**OCD ENVIRONMENTAL BUREAU**  
**SITE INSPECTION SHEET**

FACILITY NAME: DUKE - VAL VERDE GAS PROCESSING PLANT 600 MACT/D  
PHYSICAL LOCATION: \_\_\_\_\_

Subject: Val Verde Gas Processing Plant  
Discharge Plan GW-51  
San Juan County, New Mexico

Re: Val Verde Gas Processing Plant  
Discharge Plan GW-051 Renewal Application  
San Juan County, New Mexico

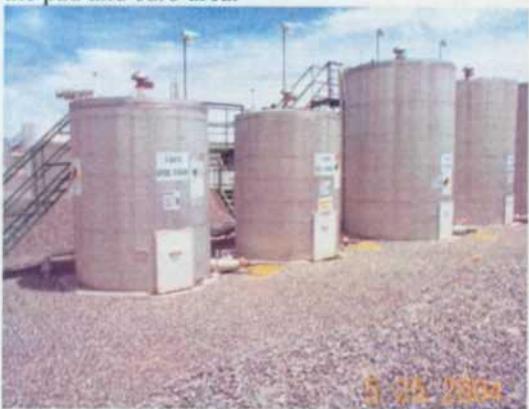
Main process area looking south.

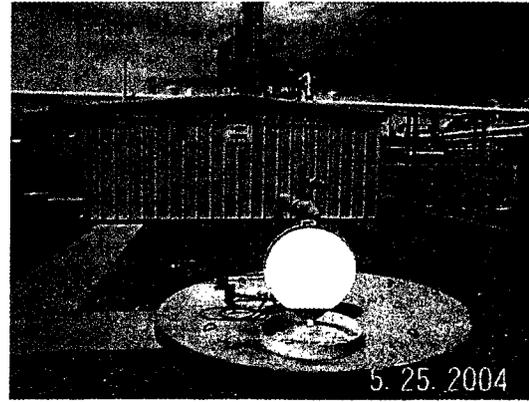
Main process area looking south.

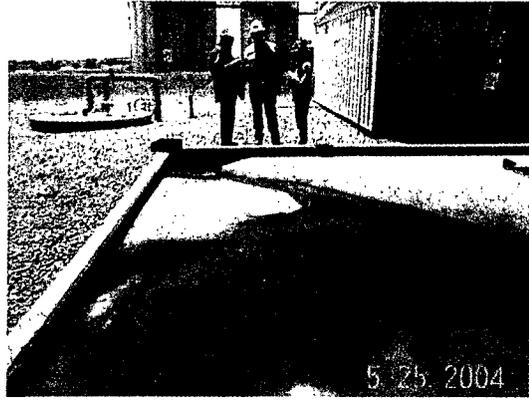
Process units with Amine and water standing in the pad and curb area.

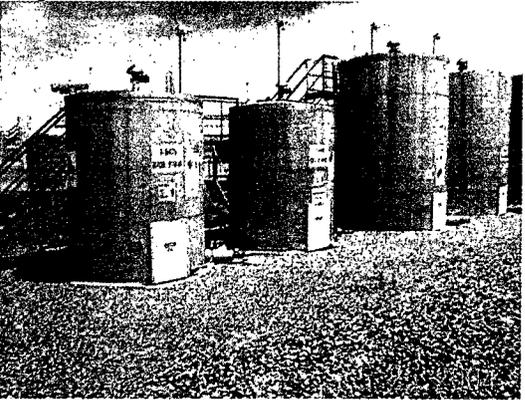
Steam and wash off pad with single line sump. Sump had standing fluids.

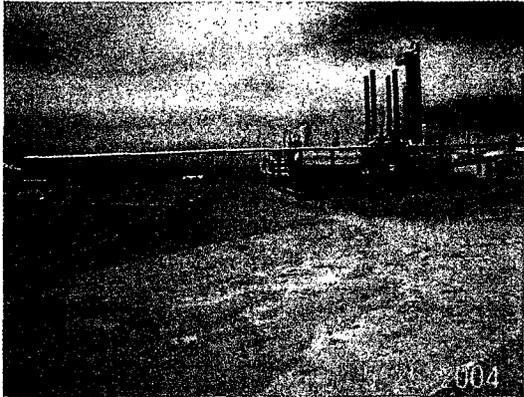
Another process unit. Process unit with Amine and water standing in the pad and curb area.
